# PARTS & SERVICE NEWS

REF NO.	AT03124
DATE	Jul. 4, 2003

**SUBJECT:** REPAIR PROCEDURE FOR BODY HEATING EXHAUST PIPE ON HM300-1

**PURPOSE:** To introduce modification procedure to repair the body heating exhaust pipe on HM300-1 articulated dump trucks

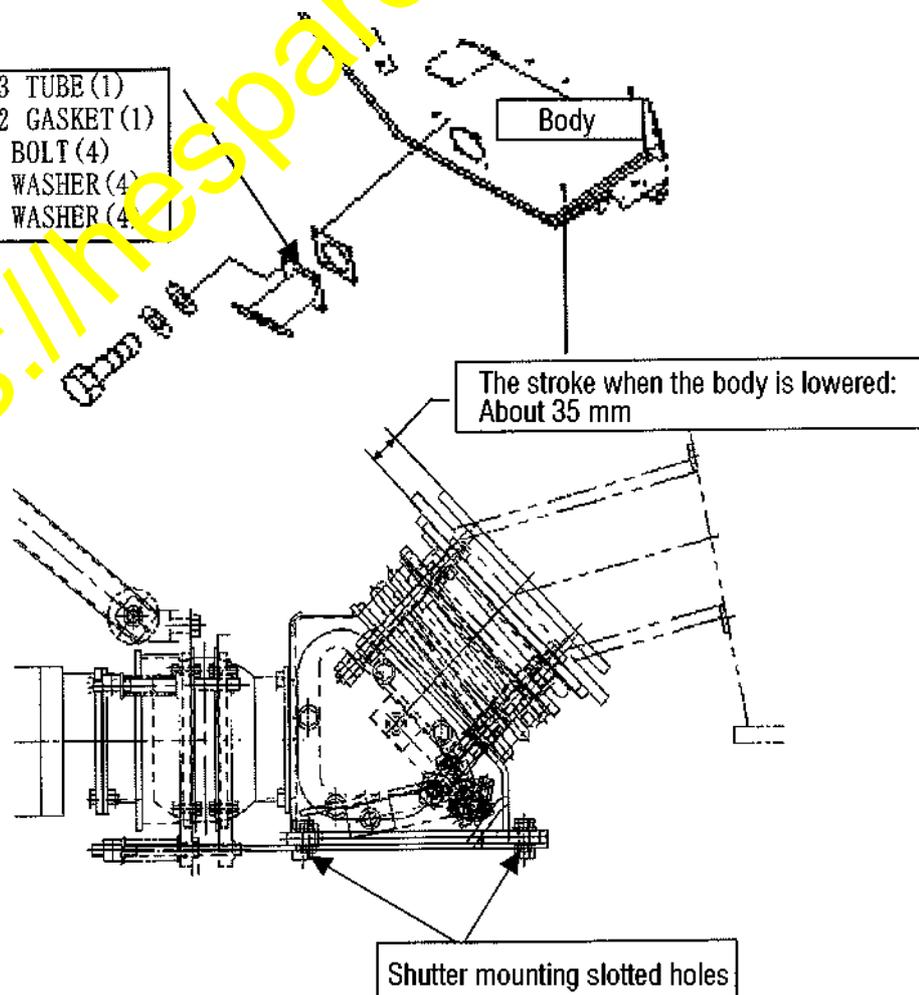
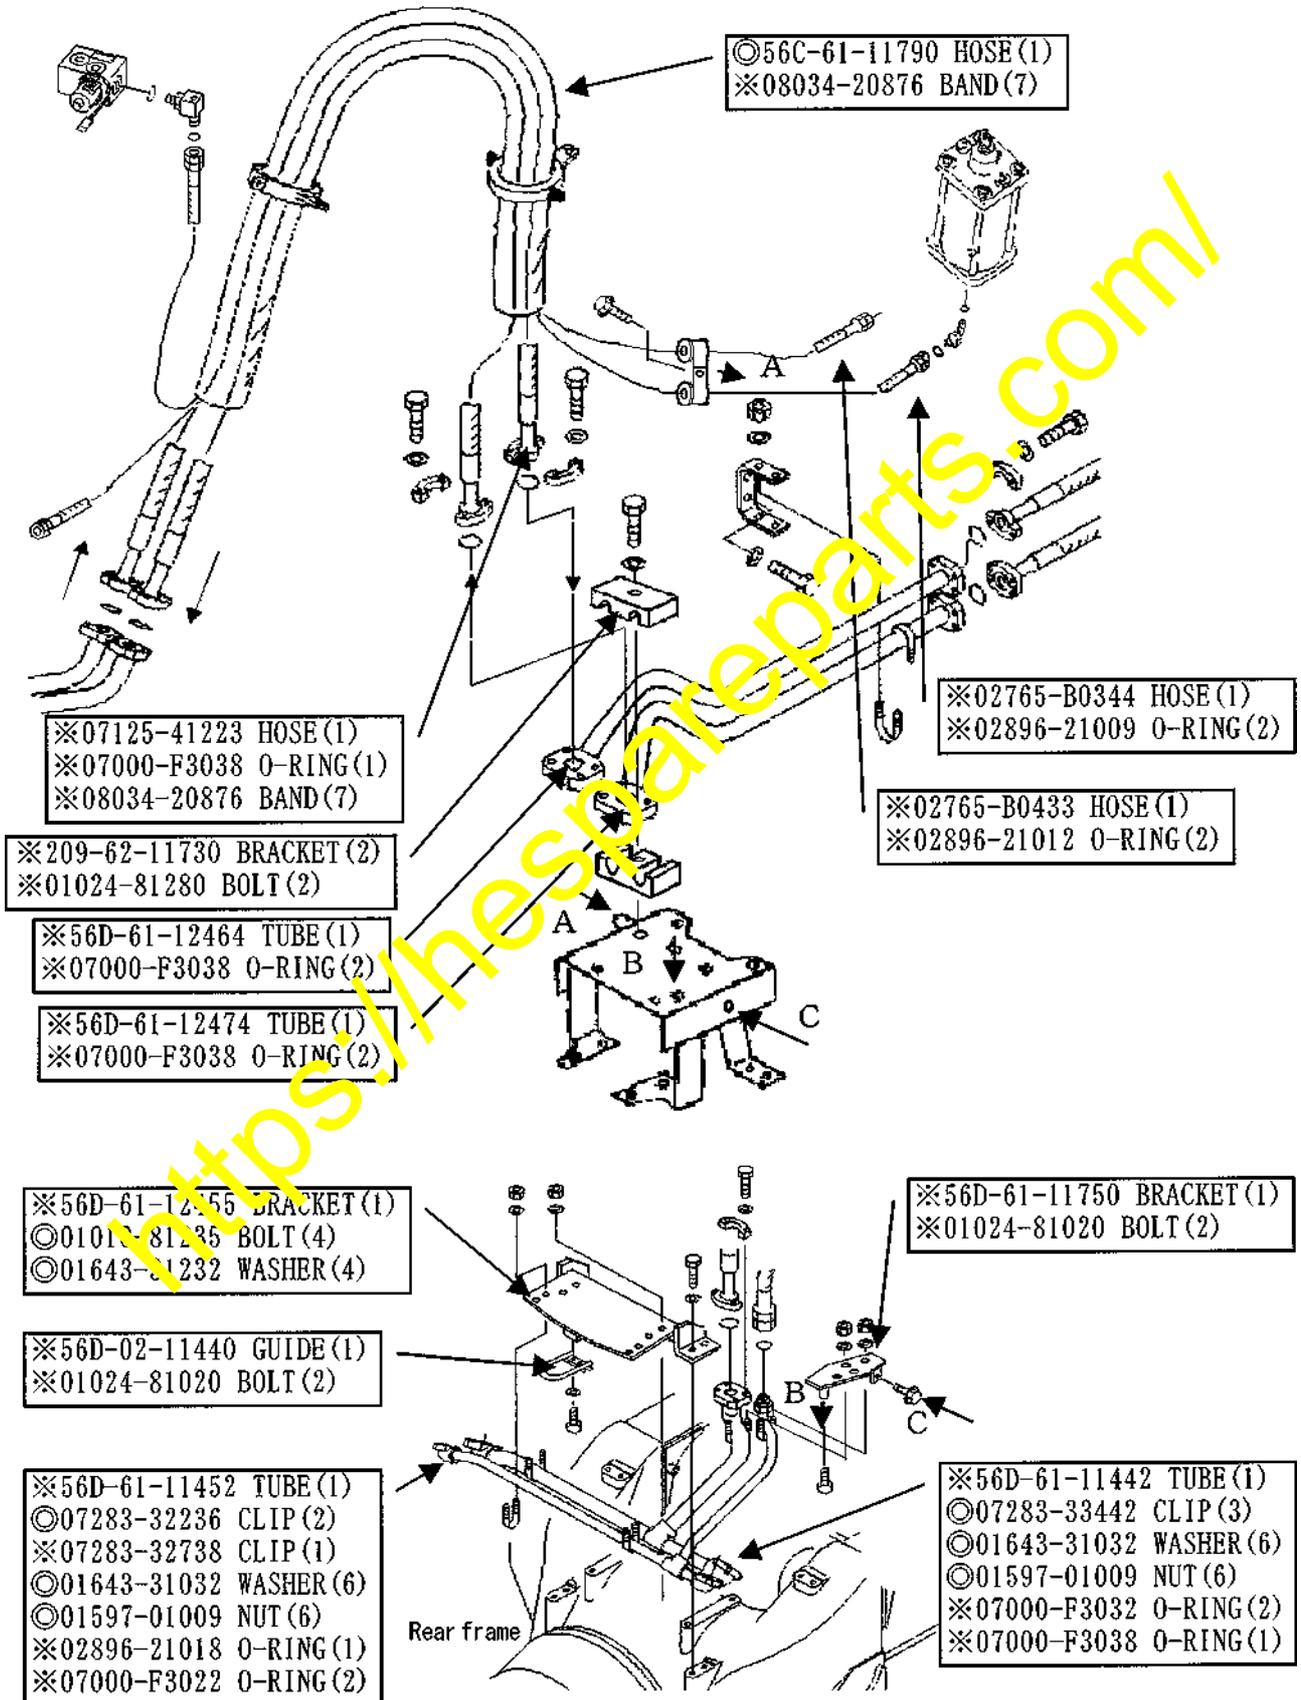
- 8) Install the tube (56D-02-11383) to the front surface of the body.  
After the installation work, adjust the mounting position of the shutter so that the contraction stroke of the shutter when the body is lowered may become 35 mm using the shutter mounting slotted holes.

※56D-02-11383	TUBE (1)
※56B-74-11172	GASKET (1)
※01010-81645	BOLT (4)
※01643-31645	WASHER (4)
※01643-31845	WASHER (4)

- 9) Install the bracket (56D-61-12455) and guide (56D-02-11440) to the rear frame.
- 10) Install the tubes (56D-61-12442 and 56D-61-11452) and bracket (56D-61-11750).
- 11) Install the tubes (56D-61-12464 and 56D-61-12474) and bracket (209-62-11730) to the rear frame.
- 12) Install the hoses {02765-B0344(1), 02765-B0433(1) and 07125-41223(2)} and tie them by use of the band (08034-20876).
- 13) Install the hose (56C-61-11790) and bundle it by use of the band (08034-20876).

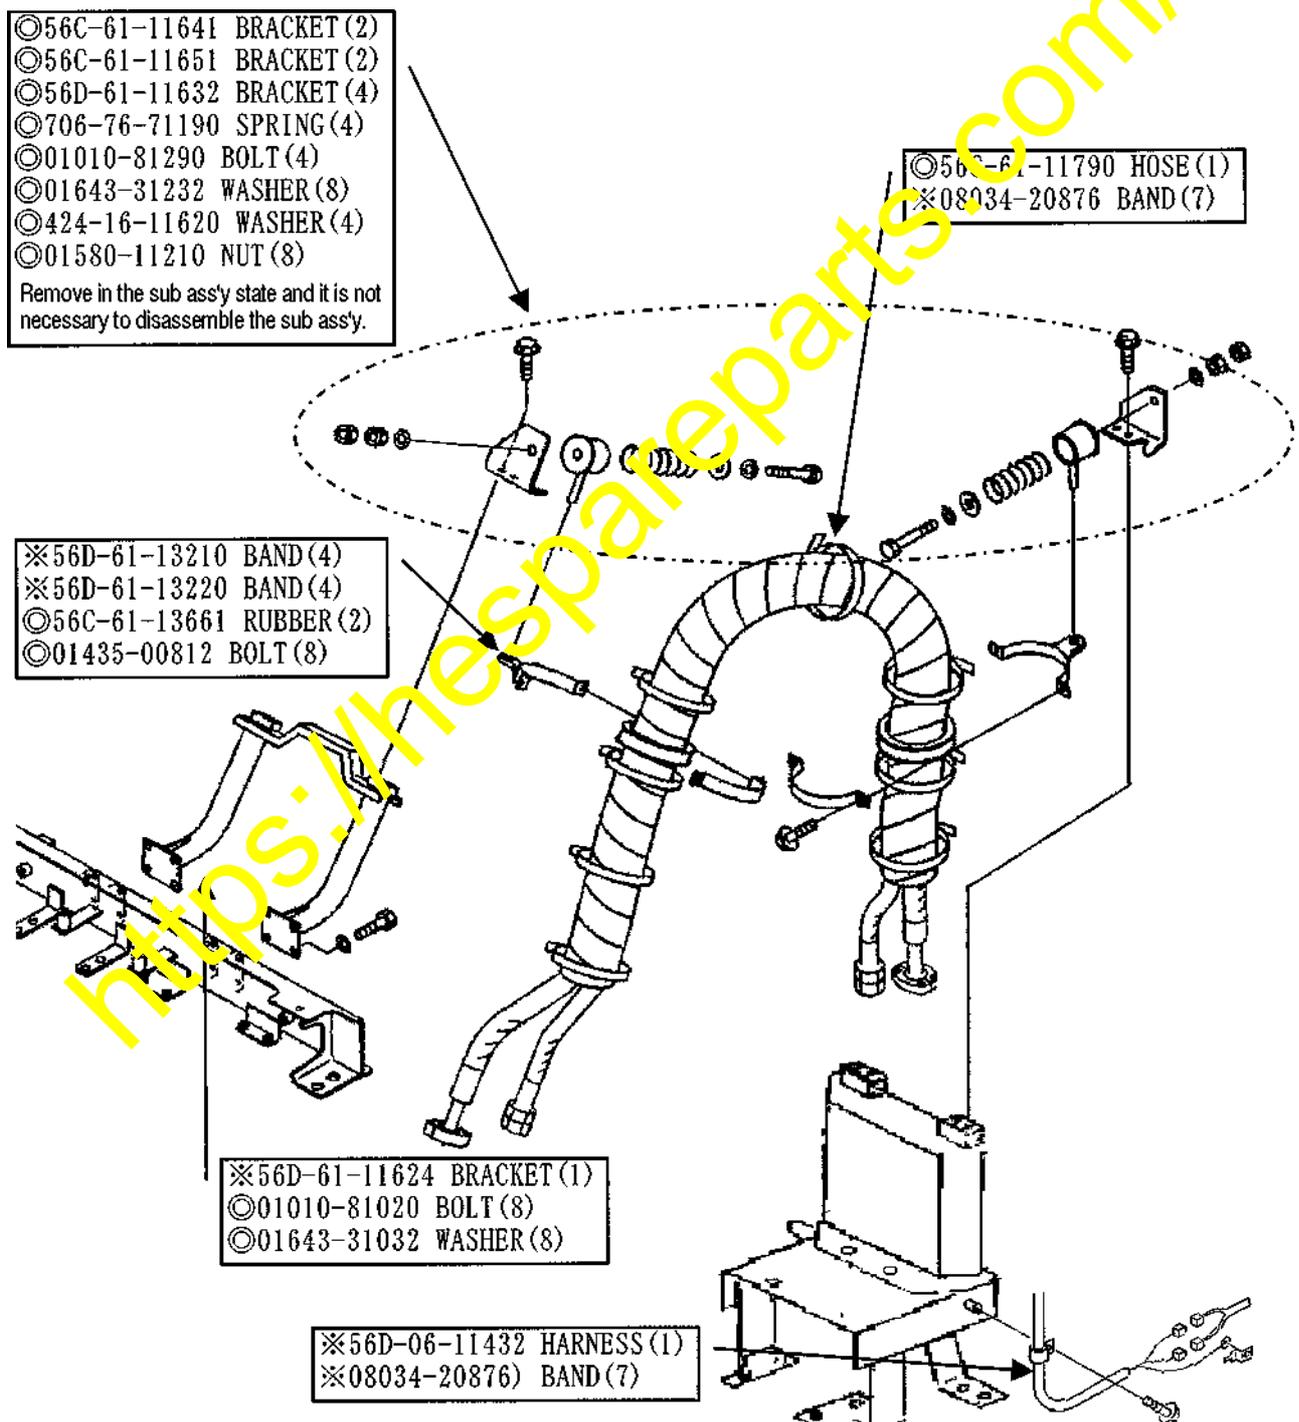
- 14) Install the wiring harness (56D-06-11432) and tie it by use of the band (08034-20876).
- 15) Install the hose (56C-61-11790) and bundle it by use of the band (08034-20876).
- 16) Install the bracket (56D-61-11624).
- 17) Install the bracket sub ass'y (56C-61-11641 and others).
- 18) Fasten the hoses by use of the bands (56D-61-13210 and 56D-61-13220).
- 19) After finishing the assembly work, check the following items.
  - Carry out air bleeding from the brake circuit and make sure air is not remaining inside the brake circuit.
  - Make sure oil leakage is not occurring from each section.
  - Make sure exhaust gas is not leaking.
  - Interference should not occur when steering operations are made and when oscillations are occurring.
  - The spherical joint section should turn smoothly without occurrence of seizure or prying.
